January 16, 2025

ADDENDUM #4

Coastal Carolina Community College
Learning Resources Center
First Floor Renovation
SCO ID: 23-26060-01A

E-0.8

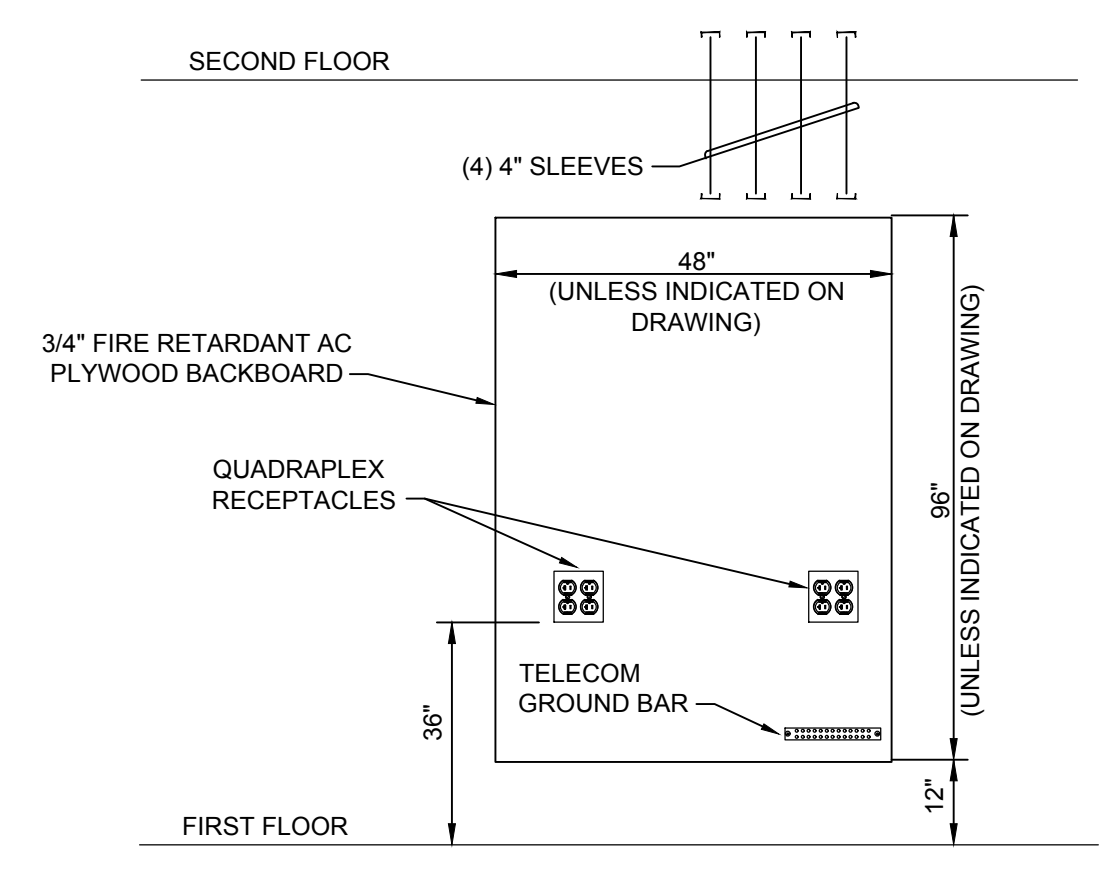
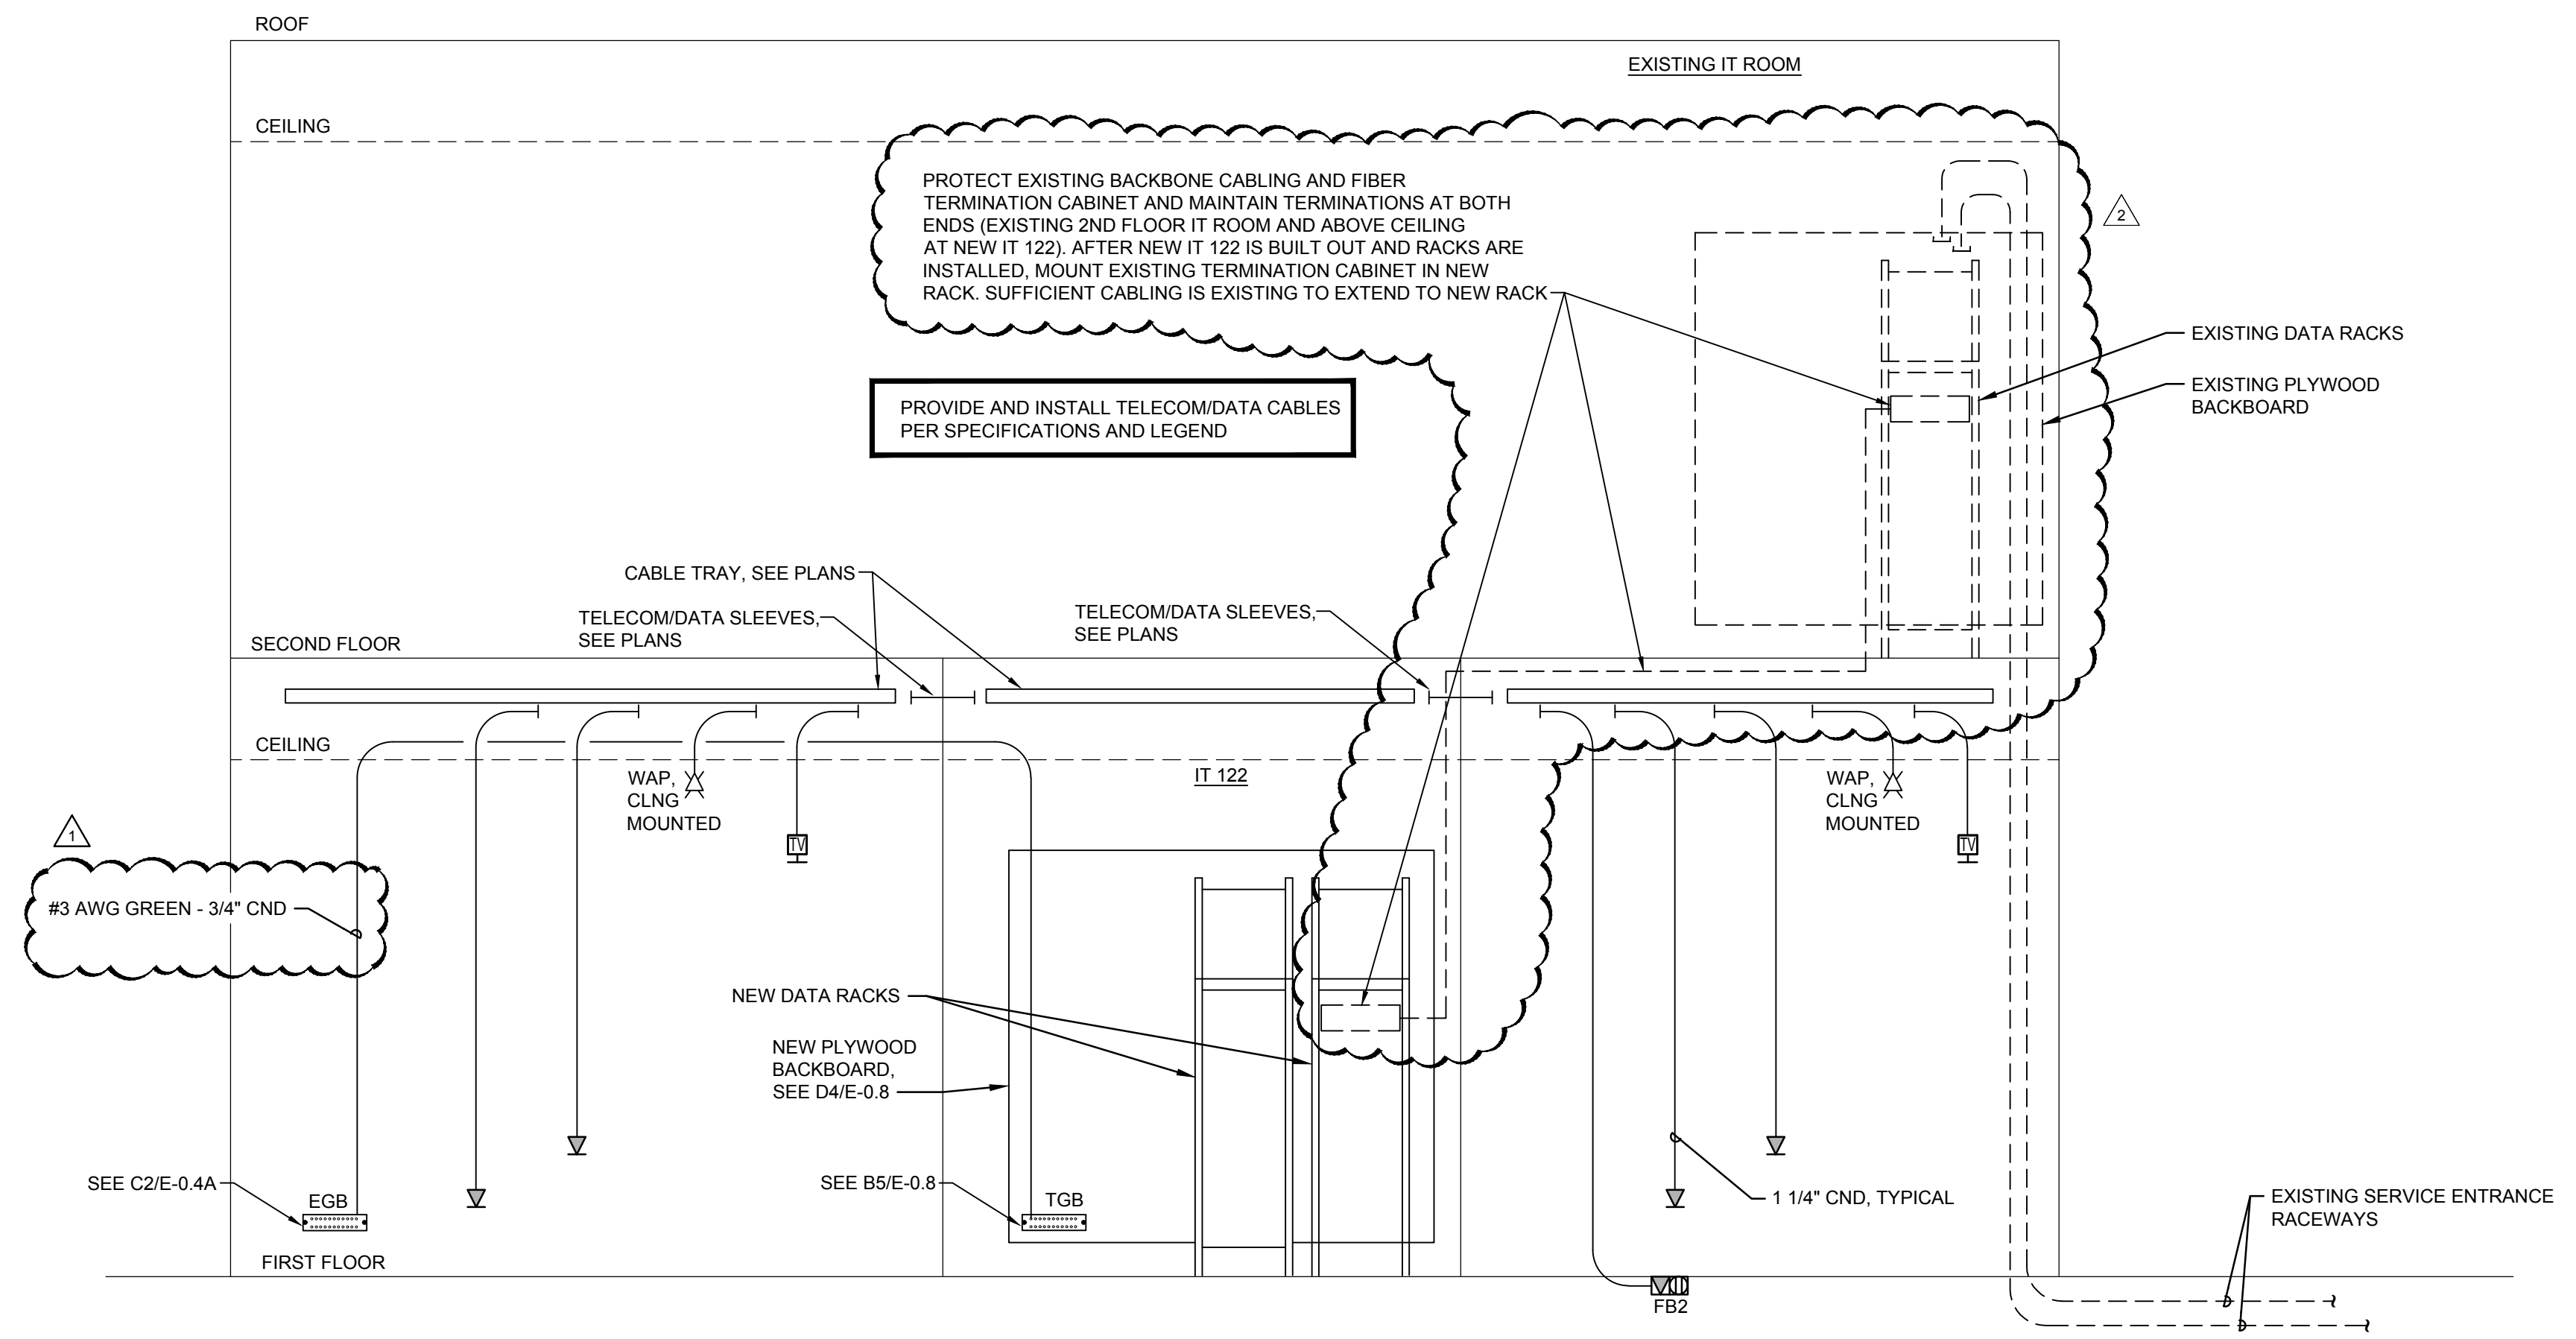
Notations have been added to drawing sheets E-0.8 and EP1.4 to protect existing backbone cabling and a fiber termination cabinet, as well as, maintain terminations at both ends (existing 2nd floor IT room and above ceiling at the location of new IT 122). Upon completion of new room IT 122 and complete installation of racks, mount existing termination cabinet in new rack. Sufficient cabling is existing to extend to new rack.
